Your ref: Docket No. 71-9239
Our ref: UAM-NRC-06-012

August 29, 2006

SUBJECT: Docket 71-9239, License Renewal Application for Certificate of Compliance No. USA/9239/AF, MCC-3, MCC-4, and MCC-5 Packages

SHEET 1

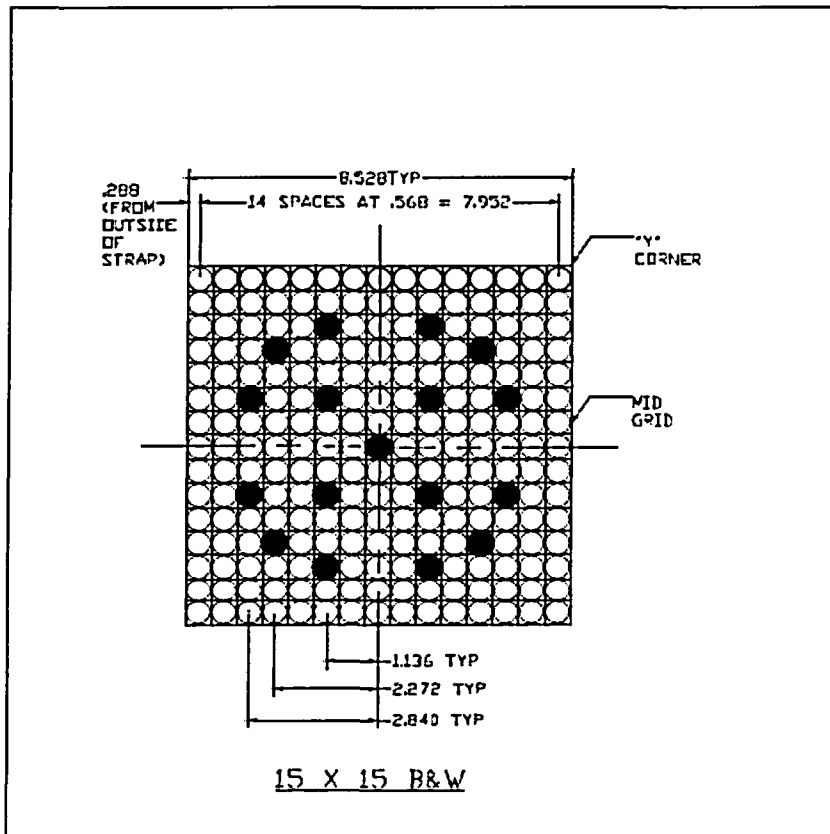
Westinghouse Drawing No. 6481E15 is revised to show the correct parameters for 15X15 B&W fuel assembly type. This change was previously approved by NRC letter dated September 27, 2004, Docket No. 71-9292, TAC No. L23765. Westinghouse Engineering Change Notice (ECN-0000378) is being processed to revise the product drawing as described below. The drawing is included in the application as fuel assembly cross sectional views in Appendix 1-3 Container Drawings. The revised drawing will be provided as an addendum to this renewal application

1. Near Zone D6/D5, replace the 15 X 15 GPU/B&W fuel assembly loading pattern with the pattern shown below including the technical title.
